**MEMORIAL PARK  
WASTEWATER TREATMENT FACILITIES  
IMPROVEMENT PROJECT**

**COUNTY PROJECT NO. P23P4  
PROJECT FILE NO. E4955**

**ADDENDUM NO. 1**

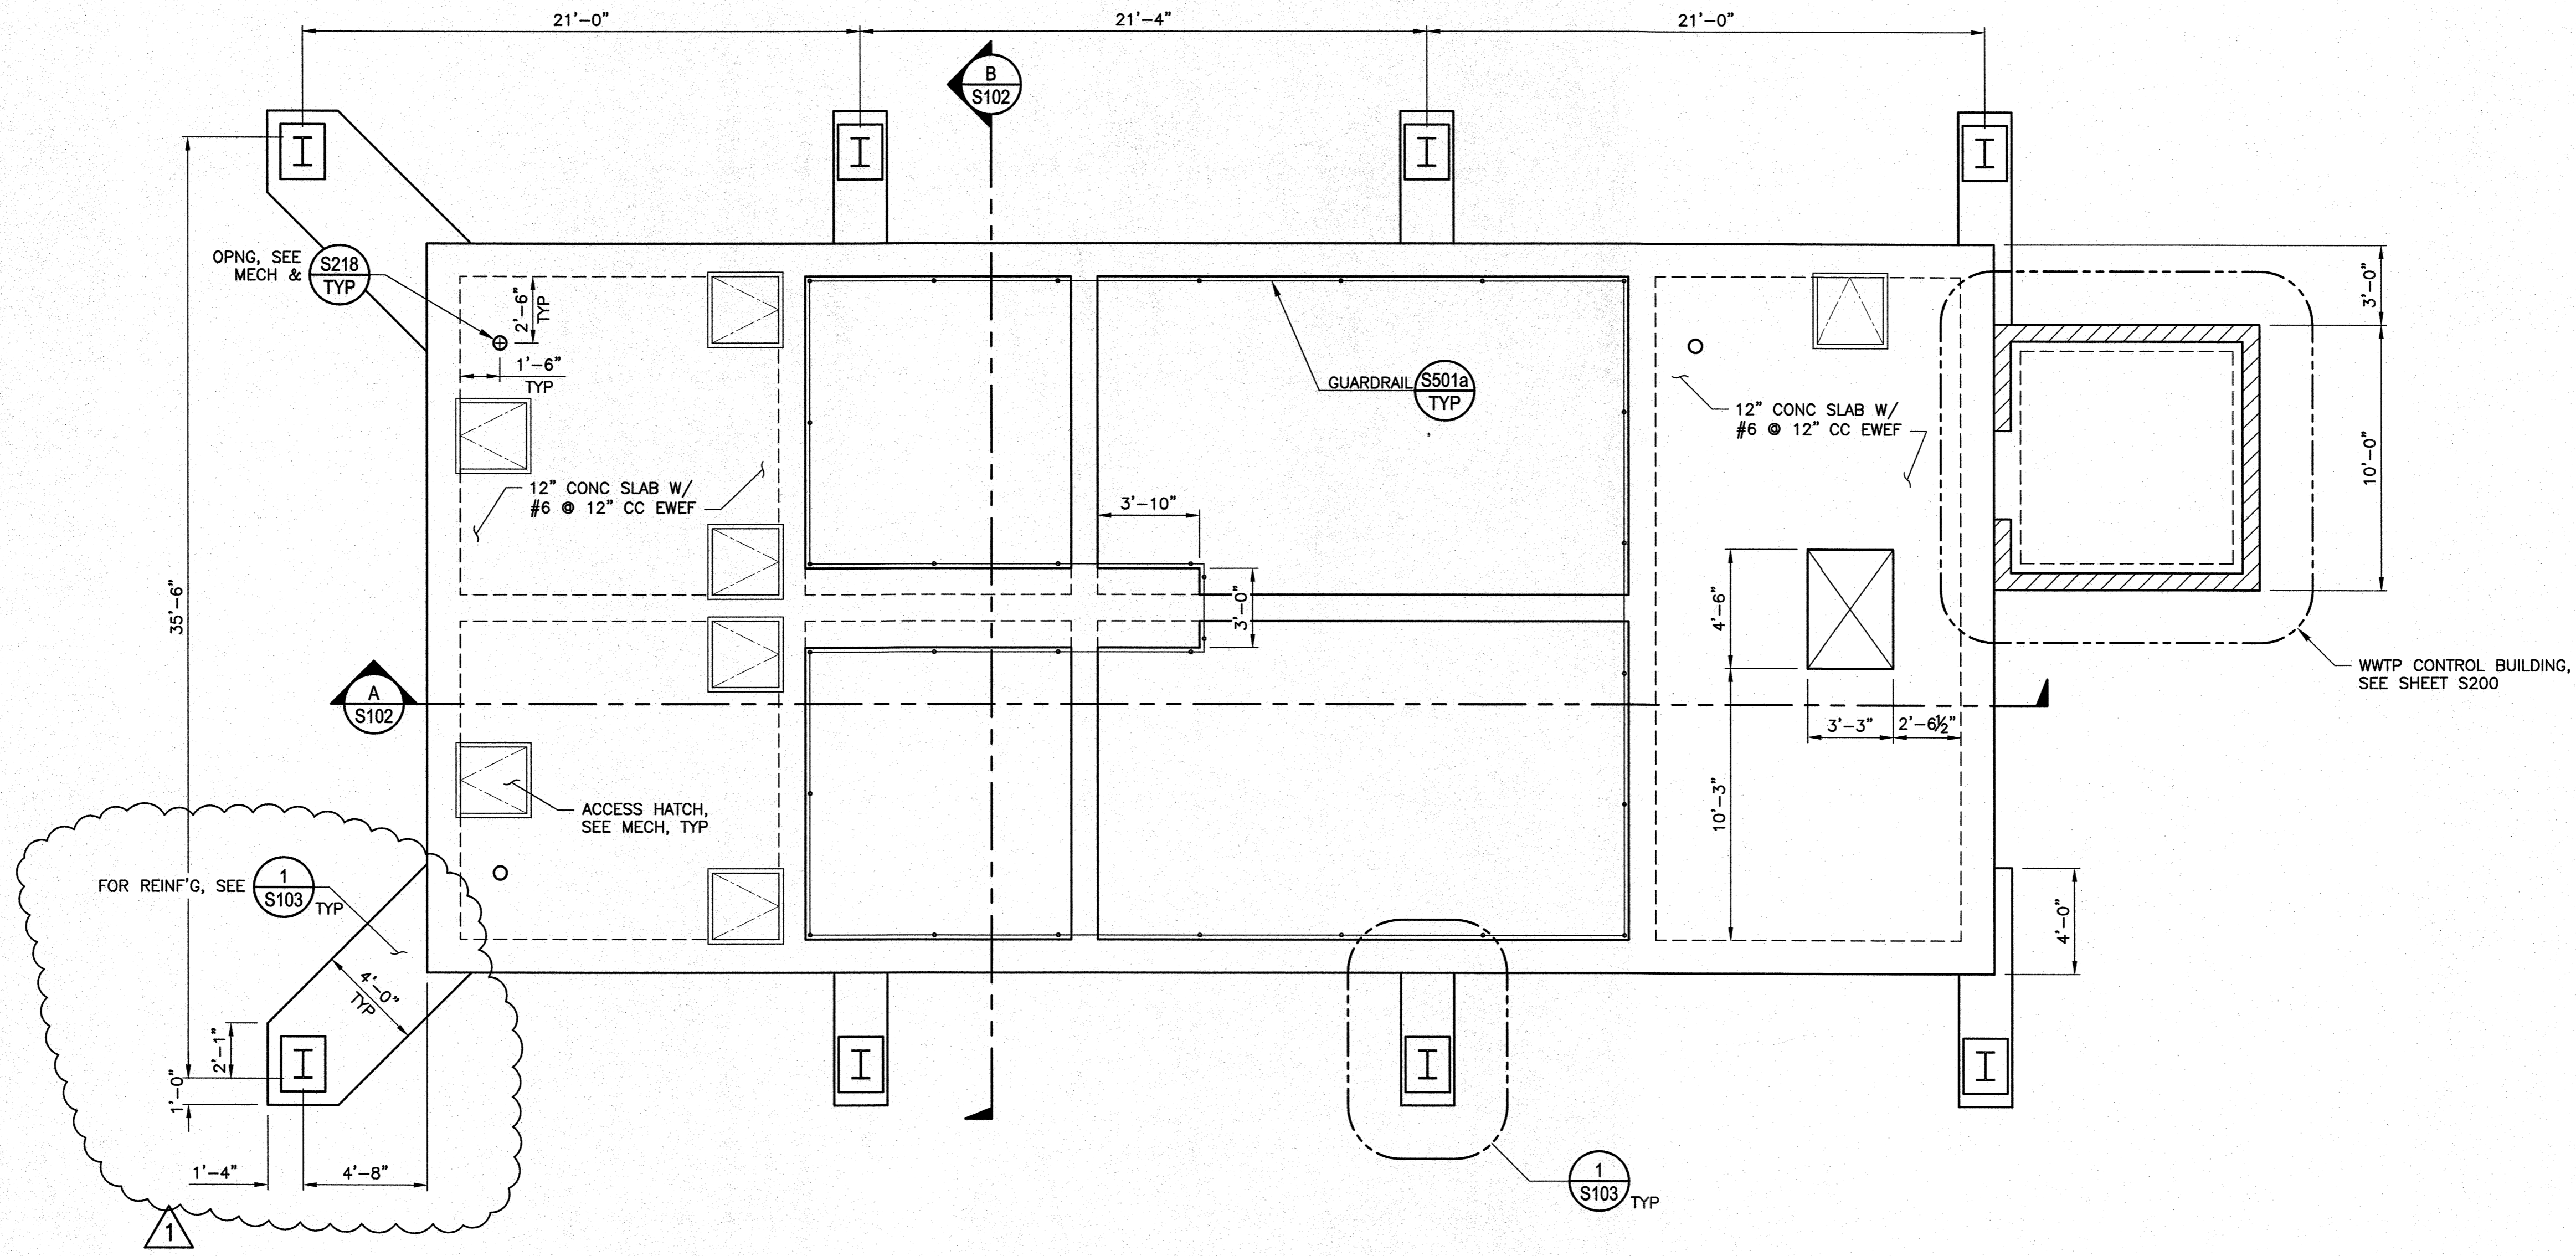
8. Page S101 of the Plans shall be replaced in the Project Plans:

**Replace page S101 (Sheet 39 of 57) of the Plans with page S101 (rev) (Sheet 39 of 57).**
